TECHNICAL SERVICE BULLETIN

DATE ISSUED	MODEL YEAR(S) AFFECTED	TSB #
3/24/2016	2016	449 rev. A

NHTSA# 16V 041, TC # 2016-034

How to Install a New Chassis Information Label

Method #1: Removing the Original Label

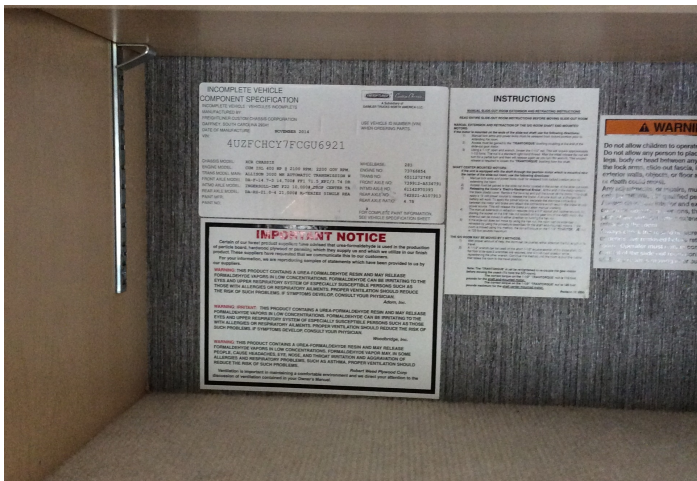
Original Incorrect Label

2. Clean the existing label with rubbing alcohol. If the edges are peeling, it may be easier to remove the label. If you are installing a new label over the top of the existing label, take care to align the new label directly over the old label so that it is covered completely.

3. Install a clear protective film over the new label.
4. Repeat the process for the label in the kitchen cabinet.

Method #2: Installing New Label over the Original Label

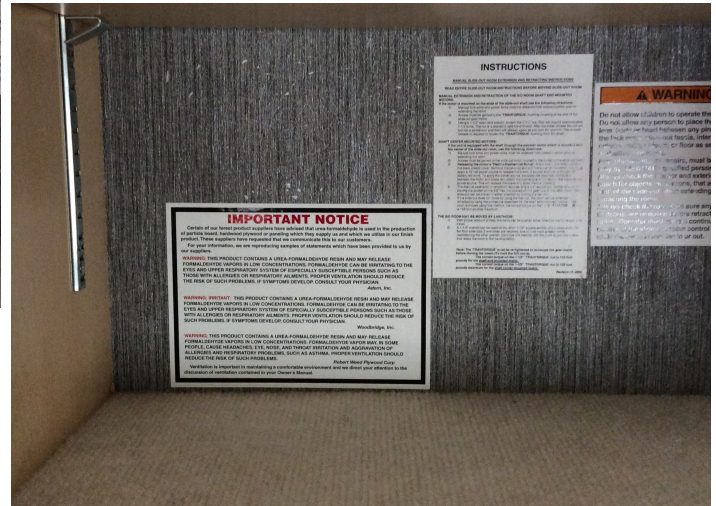
Original Label Installed

Protective Film

New Label Installed

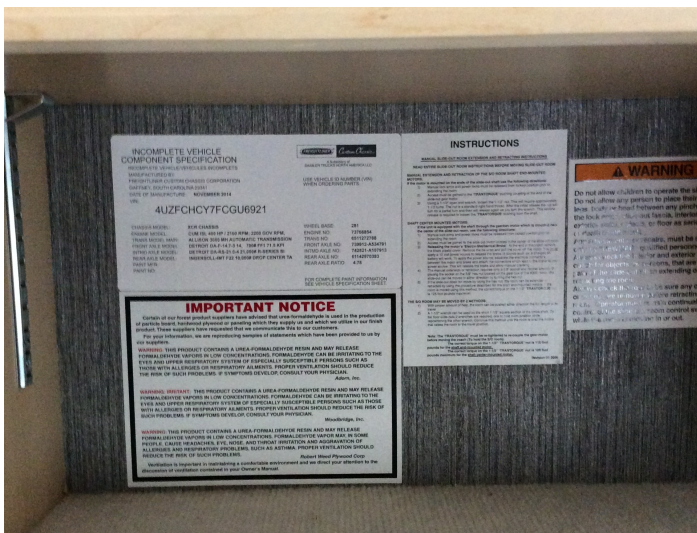
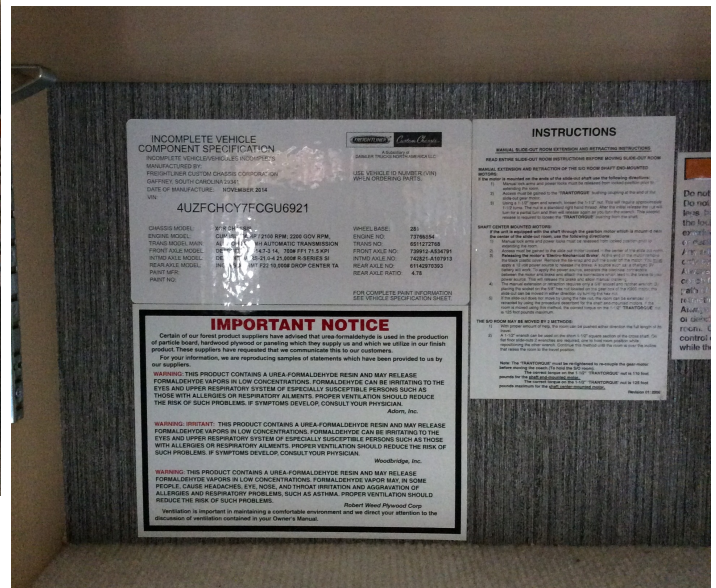
5. Locate the label in the kitchen cabinet. To install the new label, clean the existing label with rubbing alcohol. If the edges are peeling, it may be easier to carefully remove label. If you are installing a new label over the top of the existing label, take care to align the new label directly over the old label so that it is covered completely.

Old Label Removed

6. Install clear protective film over the new label.

New Label with Clear Protective Film
